Lead Local Flood Authority

RE: WA/18/26/PL - Land off Arundel Road Fontwell

This is a full application for the erection of 64 residential dwellings with access off Arundel Road, together with associated parking, open space, play space, landscaping, drainage and infrastructure.

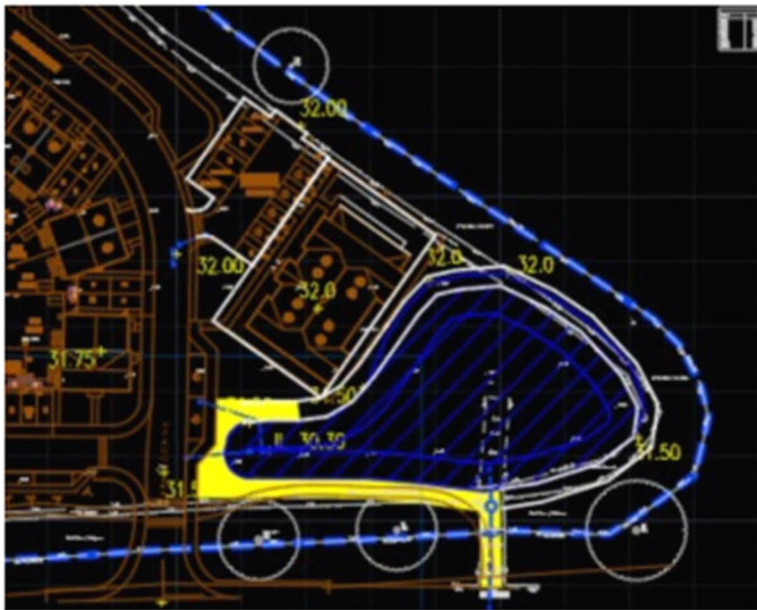
A minimum 3m easement for the attenuation basin is required, for maintenance access.

The easement shall go around the entire basin, rather than part of it. For the side near the building, it is unclear whether the basin can be safely maintained. As these issues could affect the layout and scale of the site, it would not be reasonable for the above to be covered via conditions at this stage

As requested, we require the easement to go round the entirety of the basin.

As these issues could affect the layout and scale of the site, it would not be reasonable for the above to be covered via conditions at this stage.

We have currently shown a 3m easement for maintenance for the inlet and outlet structures. Any other maintenance can be carried out from within the basin.

Notwithstanding the above we can tweak the layout to provide the 3m easement around the entire perimeter as below.
